SCAPPOOSE PLANNING COMMISSION

5.1 Docket # SDR 3-23

Jim Poppenhagen and Jenny Martinez have requested approval of an application for Site Development Review (SDR 3-23) to allow for the erection of a pre-engineered metal building to be used as a private parking facility and installing associated site amenities. The site is located at an unaddressed property off NE 1st Street, northwest of the NE Williams Street and NE 1st Street intersection, on property described as Columbia County Assessor Map #3212-AC-01100.

**CITY OF SCAPPOOSE
PLANNING COMMISSION STAFF REPORT**

PROJ. NO. 3440	PRELIMINARY SITE PLAN
DESIGNED BY RM2	MARTINHAGEN PROJECT
APPROVED BY J. POPPENHAGEN & J. MARTINEZ	SHEET
FILE D-3440-C-2-D	DATE 04/12/2023

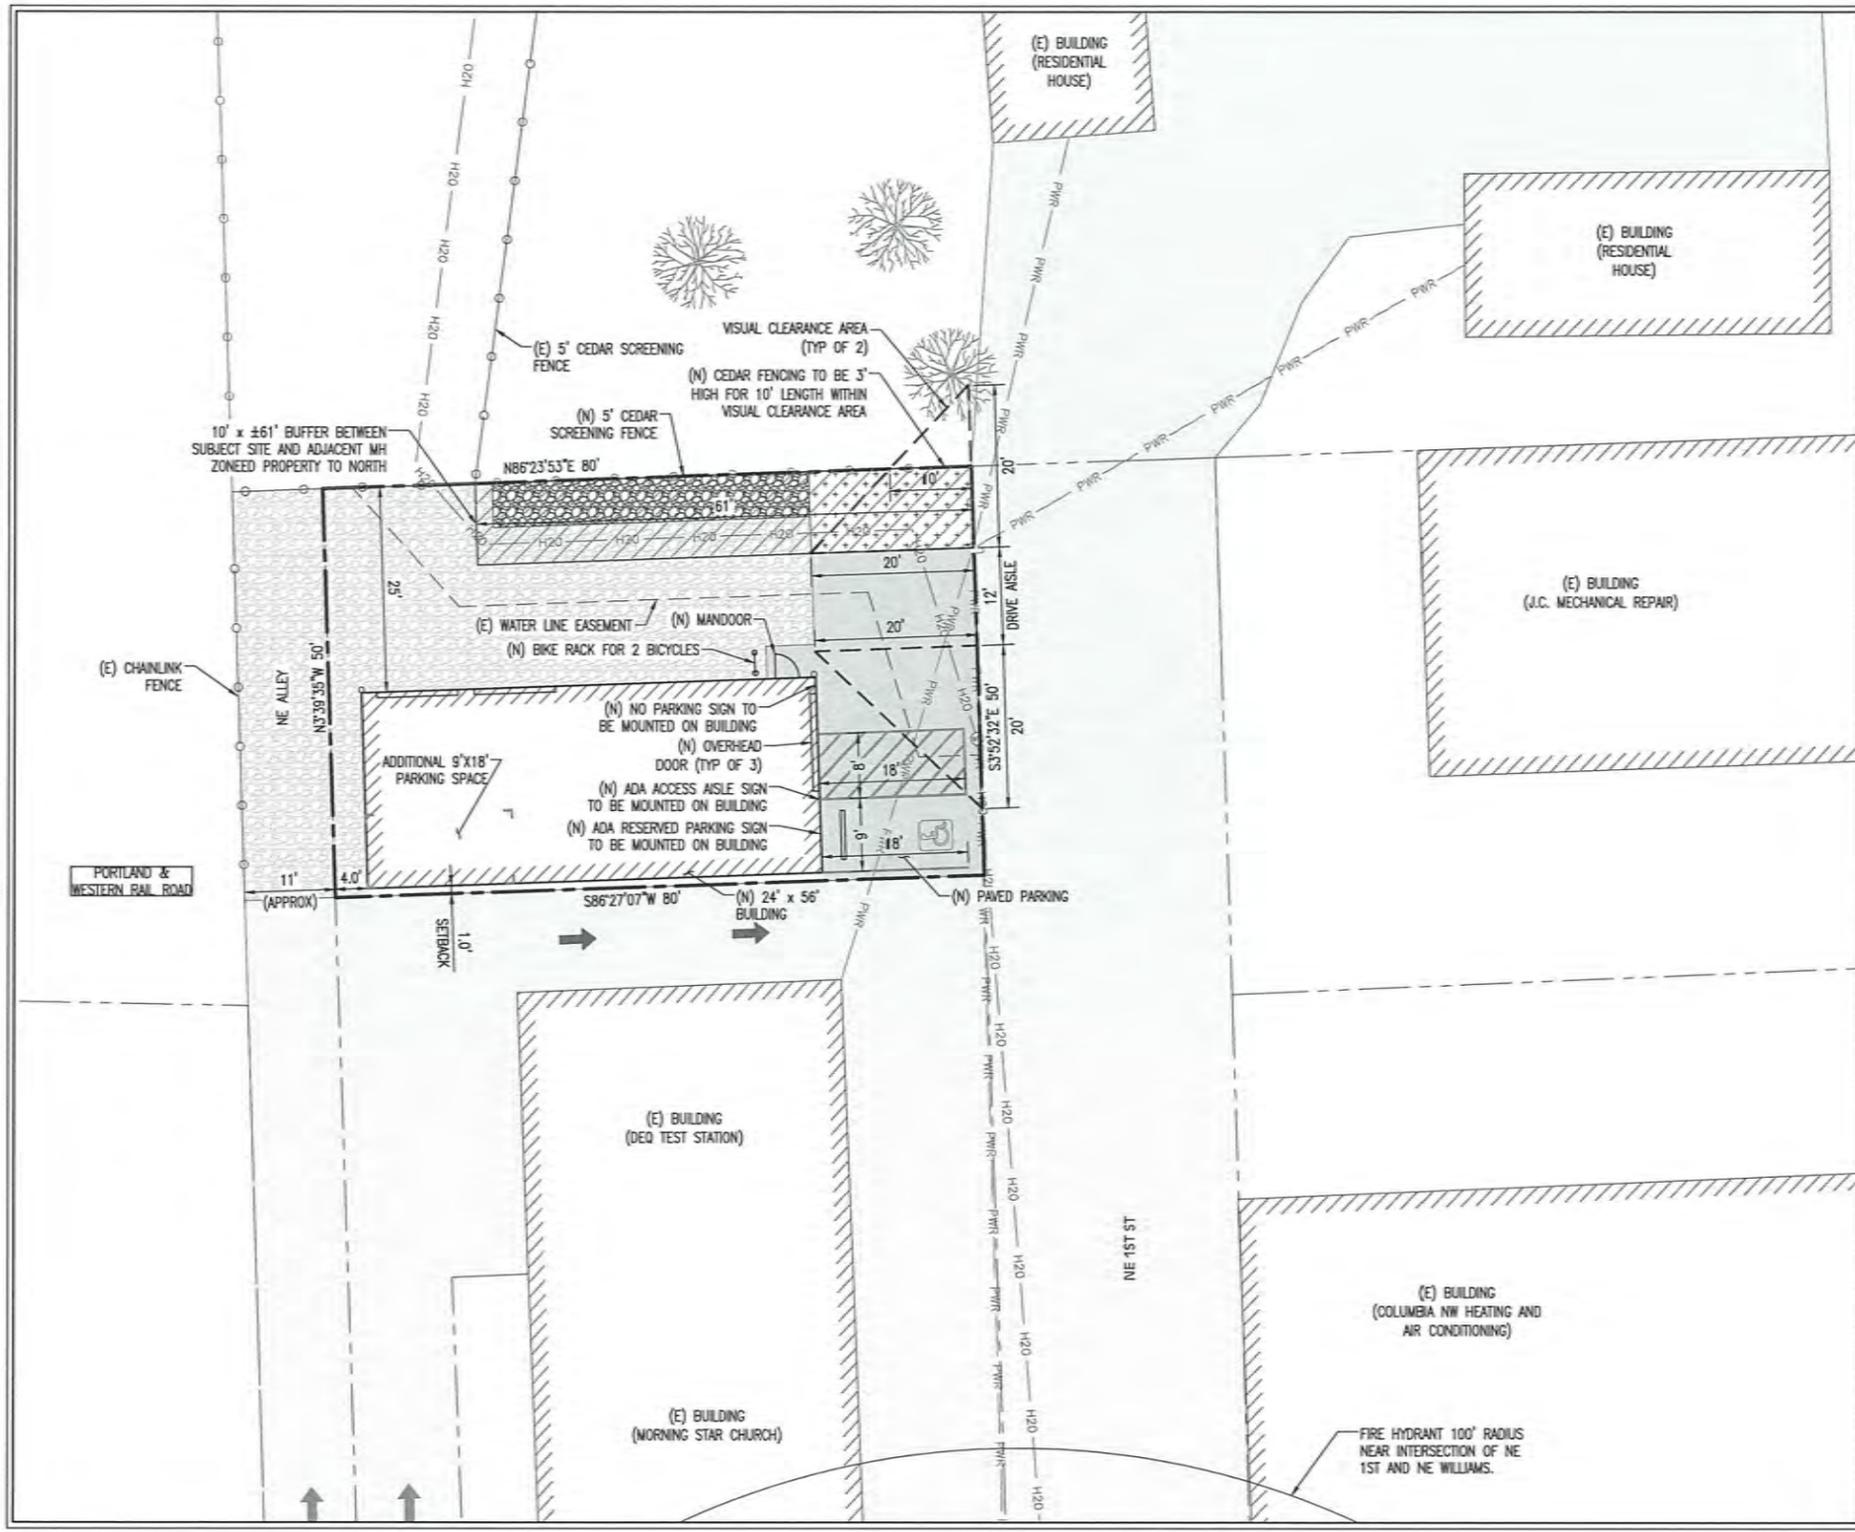
Finding: The applicant proposes to provide one new driveway along the eastern edge of the parcel as the primary access point from NE 1st Street. The Preliminary Site Plan (**Exhibit 4C**) demonstrates the provision of a visual clearance area (VCA) on each side of the driveway. There are no intersections of two streets or a street and a railroad adjacent to the site (see **Exhibit 4C**). Section 12.10.020(A) is satisfied.

Finding: The VCAs do not contain any of the items listed above with the exception of hedges and plantings (see **Exhibit 4C**). The recommended Conditions of Approval require that the applicant regularly trim and maintain hedges and plantings within the VCA so they remain no more than 3 feet in height. In order to maintain a vehicle-free VCA, the recommended Conditions of Approval require the applicant to place a “No Parking” sign on the building for areas where parking would impede the VCA. The Preliminary Site Plan (**Exhibit 4C**) shows the provision of one “No Parking” sign, per staff recommendations. Section 12.10.020(B) is satisfied.

Finding: The applicant is proposing to provide two standard sized parking spaces, with one of them being an accessible parking space (see **Exhibit 4C**), in conformance with the Americans with Disabilities Act (ADA). Each standard parking space is shown to be at least 9 feet wide and 18 feet long (see **Exhibit 4C**). No compact spaces are proposed. According to Oregon Revised Statute 447.233(1)(c), accessible parking spaces shall be at least 9 feet wide and shall have an adjacent access aisle that is at least 6 feet wide. Oregon Revised Statutes supersedes the Scappoose Development Code and so the State's standards will be applied. The applicant is proposing the provision of one accessible parking space and it is 9 feet wide and 18 feet long with an 8-foot-wide access aisle to its north (see **Exhibit 4C**), which meets the requirements for a van accessible space. The recommended Conditions of Approval will require the applicant to provide signage on the building, indicating the areas dedicated to the accessible parking space and access aisle, respectively. The applicant is showing the provision of these signs on their Preliminary Site Plan (**Exhibit 4C**). Section 17.106.020(A) is satisfied.

Finding: The proposed site has one parking space that is on the boundary of the parking lot (see **Exhibit 4C**) and so a wheel stop will be required here. The applicant is proposing to provide a wheel stop 3 feet back from the front of the parking space (see **Exhibit 4C**). This area is not adjacent to landscaping, so landscaping in this area is not required or proposed. Section 17.106.050(H) is satisfied.

The submitted plans (sheet C-2) shows the existing utility pole will be partially in the drive aisle and will be subject to vehicle traffic. Steps to protect the pole must be taken or an estimate to relocate the pole can be provided by the PUD at the customer's request.

- The Columbia River PUD provided a referral comment (**Exhibit 8**) stating that steps to protect the utility pole must be taken or an estimate to relocate the pole can be provided by the PUD at the customer's request. This requirement is included in the recommended Conditions of Approval.

5. The applicant shall place a "No Parking" sign on the building for areas where parking would impede the visual clearance area.
6. The applicant shall maintain all setbacks as illustrated in the Preliminary Site Plan (**Exhibit 4C**).

PROJ. NO. 3440	GRADING AND UTILITY PLAN
DWG. BY RM2	MARTINHAGEN PROJECT
APPR. BY J. POPPENHAGEN & J. MARTINEZ	SHEET
FILE D-3440-C-3-C	DATE 04/24/2023 Page 95 of 171

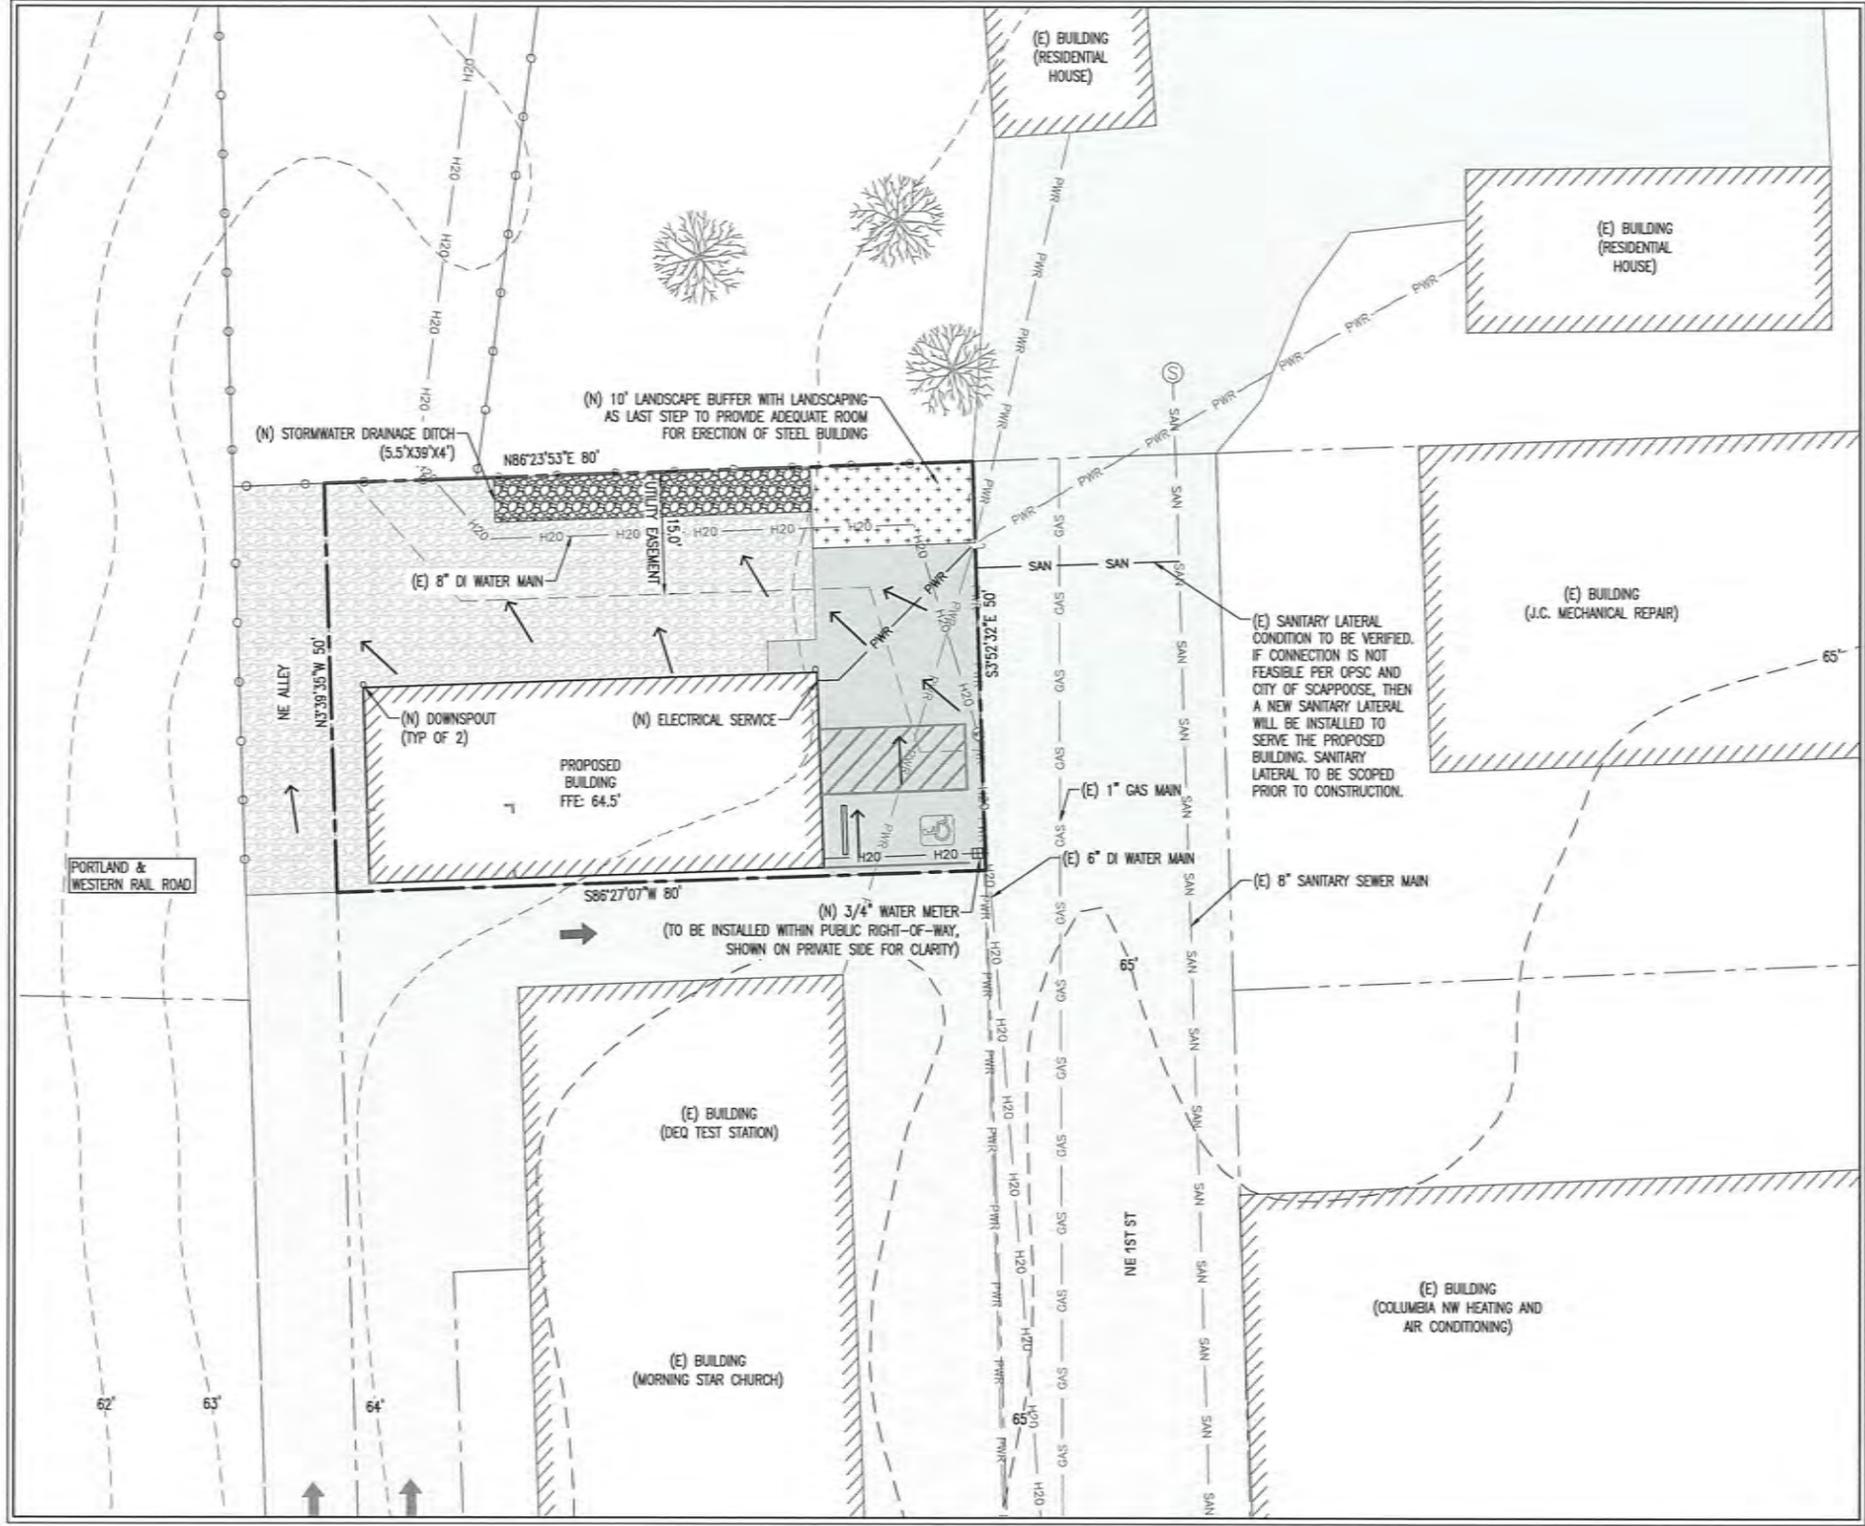
Due to the location of the stormwater drainage ditch, existing water main, and utility easement (see **Exhibit 4D**), it is not feasible to plant trees along the northern property line where the subject site is adjacent to the residential use, as outlined in this section. As an alternative, the applicant is proposing to consider the three existing large fir trees between the subject site and the 1st Street Apartments to satisfy the tree requirements for buffering (**Exhibit 4F**). Staff is in agreement with this approach since the residential use has already been adjacent to the existing

Finding: The Grading and Utility Plan (**Exhibit 4D**) shows that stormwater will be directed to the north, where it will be managed by a stormwater drainage ditch to be installed. Section 17.106.050(I) is satisfied.

13. The applicant shall ensure that the property is graded away from the building or meet 1804.4 of the OSSC (Oregon Structural Specialty Code).

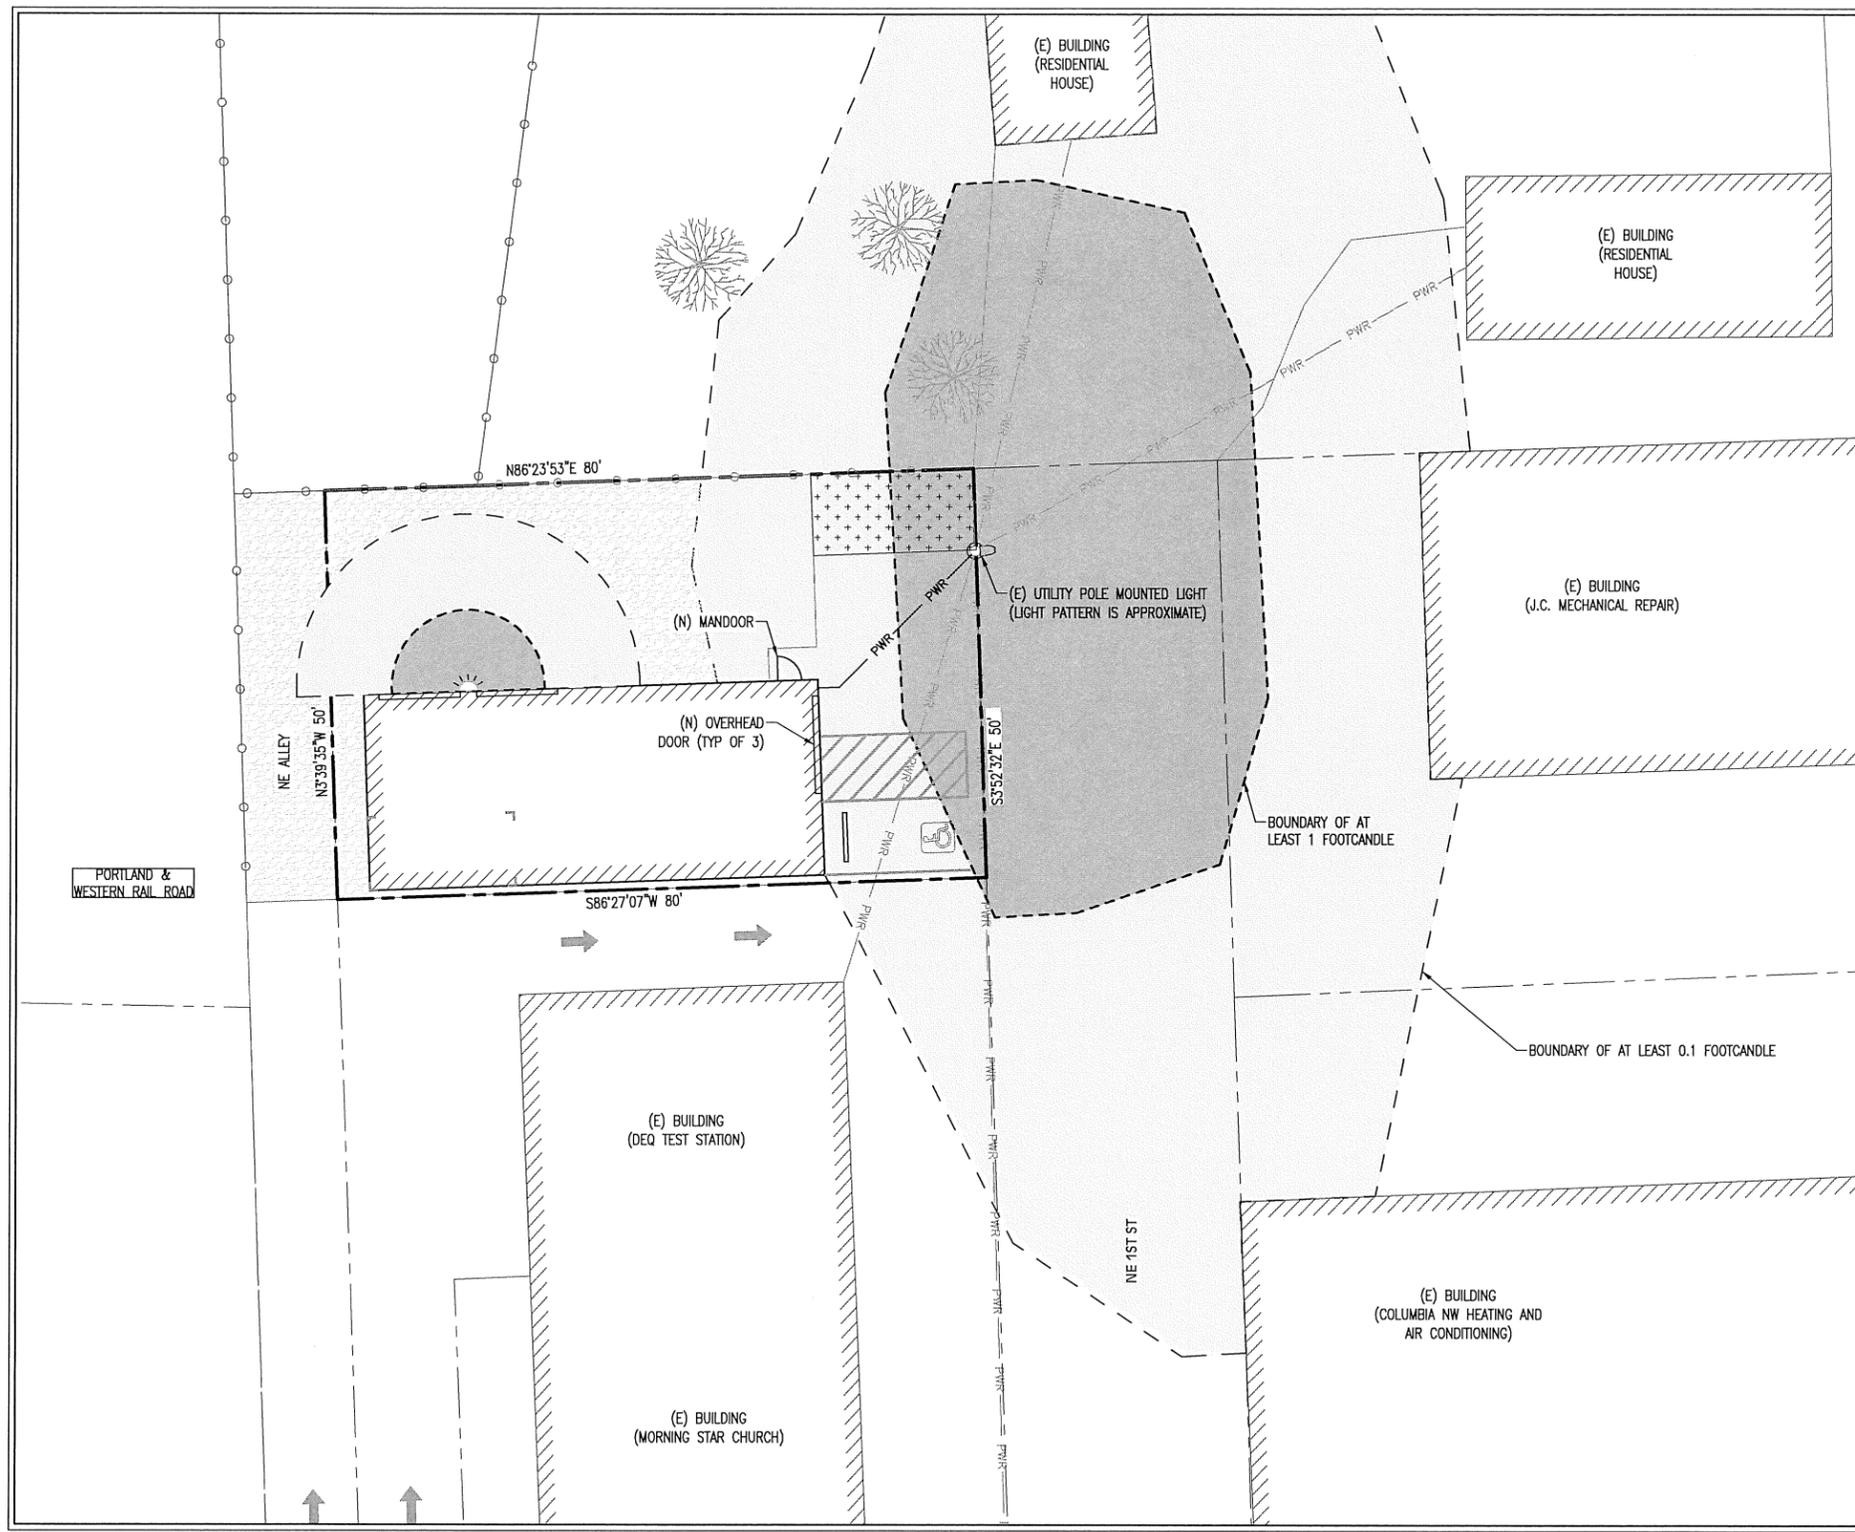
- The applicant submitted an Illumination Plan (**Exhibit 4E**) as part of their land use application.
- There is an existing streetlight that is mounted on a utility pole and provides adequate lighting to the entire width of NE 1st Street (for the length that it fronts the subject site), the site's entrance, and the proposed parking space and building entrances.
- An additional light is proposed to be placed on the exterior of the building on the northern elevation, which would illuminate the remaining areas of the site not sufficiently illuminated by the existing utility pole light.

Finding: The proposed building/site will not have windows, laundry services, or mailboxes (see **Exhibit 4C**), making criterion #1-3 not applicable. The applicant submitted an Illumination Plan (**Exhibit 4E**) to demonstrate adequate lighting levels are provided across the site, including within the surplus parking area. An existing utility pole light and a new light on the north face of the building are proposed to be used for lighting the site (see **Exhibit 4E**). Section 17.120.180(I) is satisfied.

12. The applicant shall install parking lot and site lighting in conformance with the Illumination Plan (**Exhibit 4E**). Fixture height, light type and lighting levels shall function so as to assure compatibility with neighboring land uses. Shields shall be incorporated as necessary to minimize glare and to focus lighting to its intended area. The lighting proposed to mount on the new building shall meet IES (Illuminating Engineering Society)
